Title	Blade Crash Detect Circuit	
Size B	Document Number BT7-F-0198	Rev -
Date: Thursday, January 30, 2003	Sheet 2 of 2

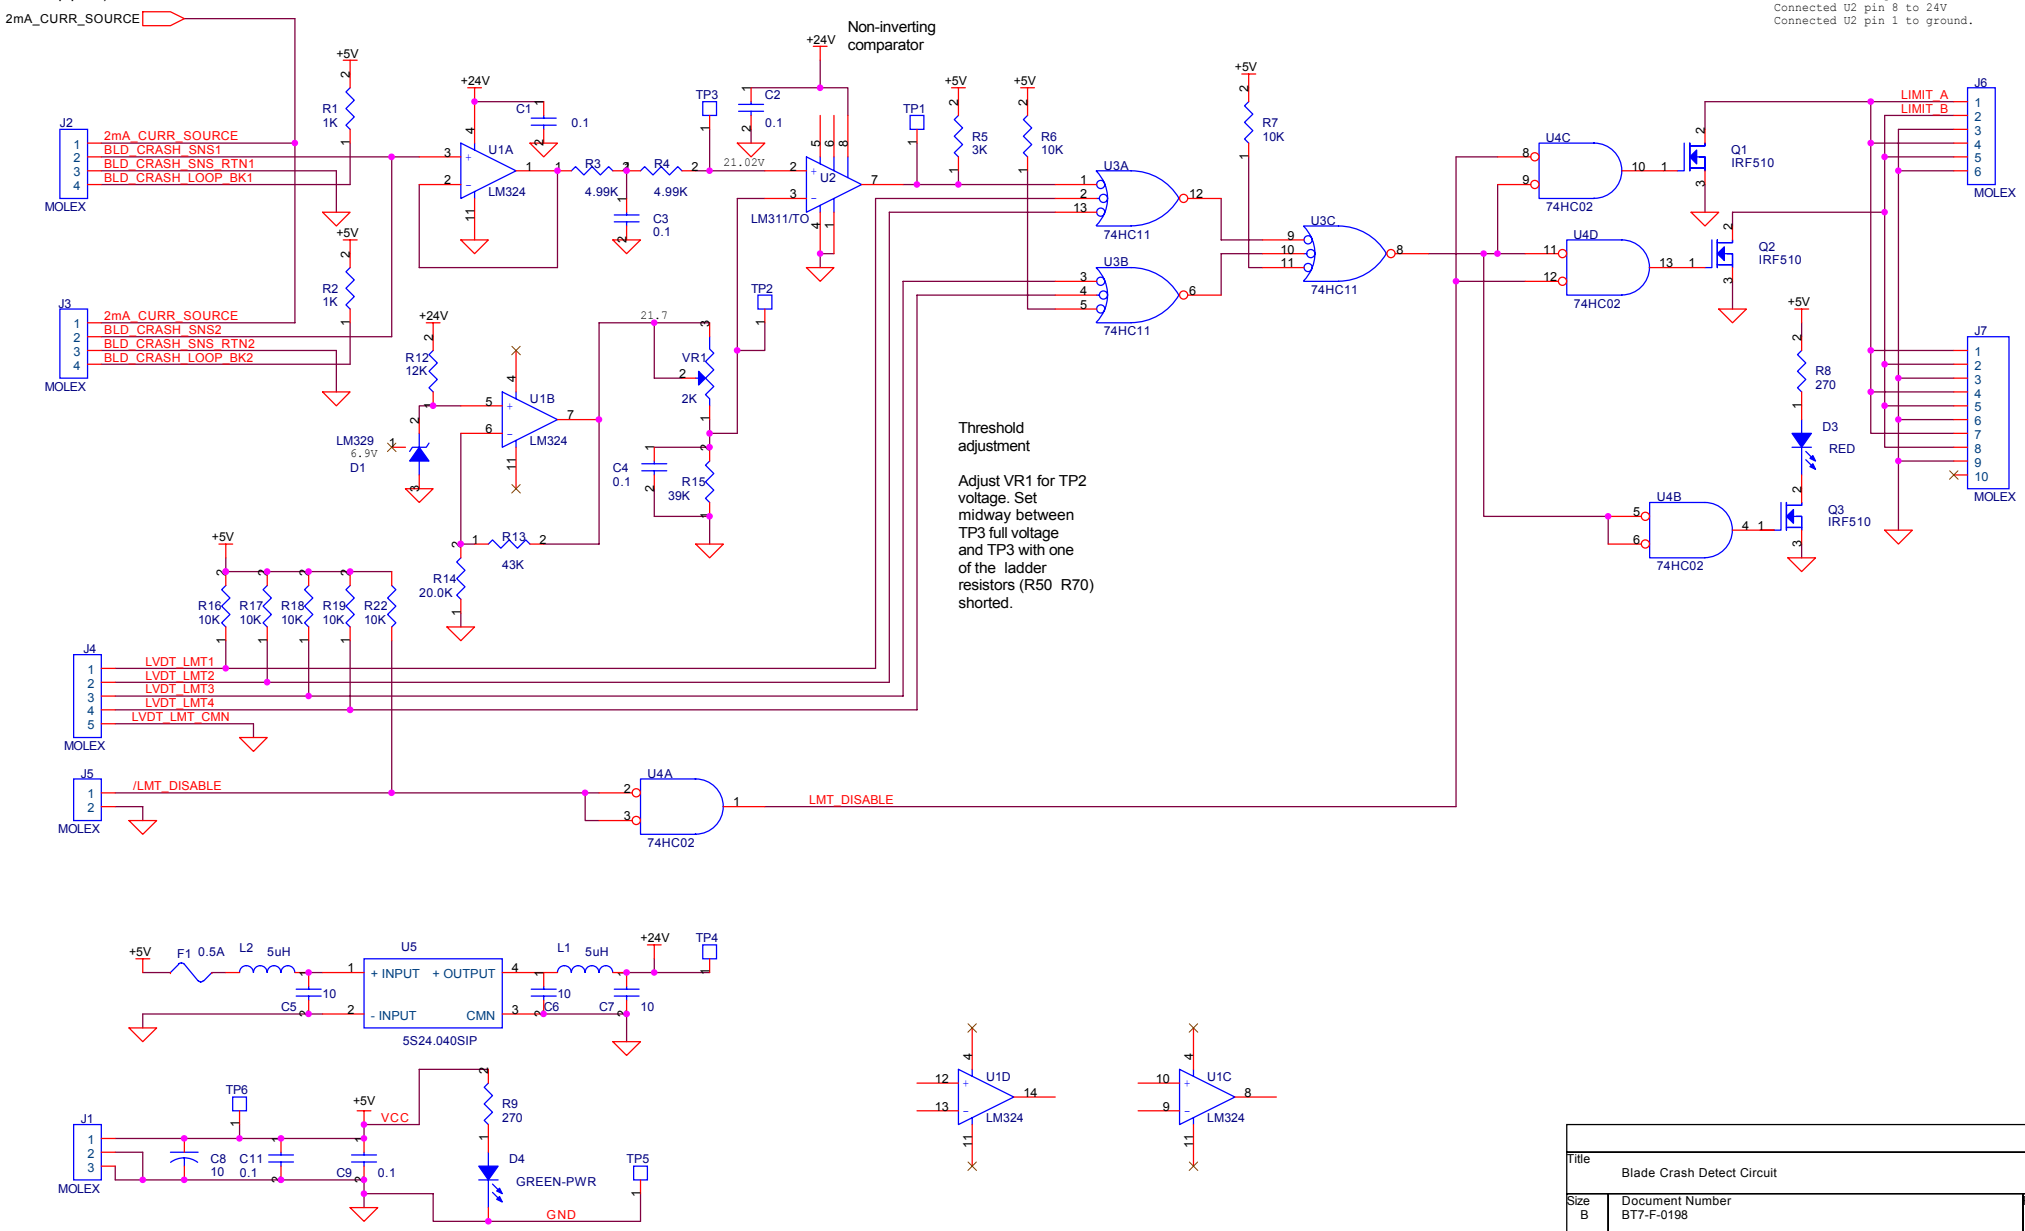
Rev A: Changed R15 from 100K to 39K
Changed R13 from 61.9K to 43K
Swapped pins 3 and 4 of U5
Disconnected U2 pin 5.
Connected U2 pin 8 to 24V
Connected U2 pin 1 to ground.
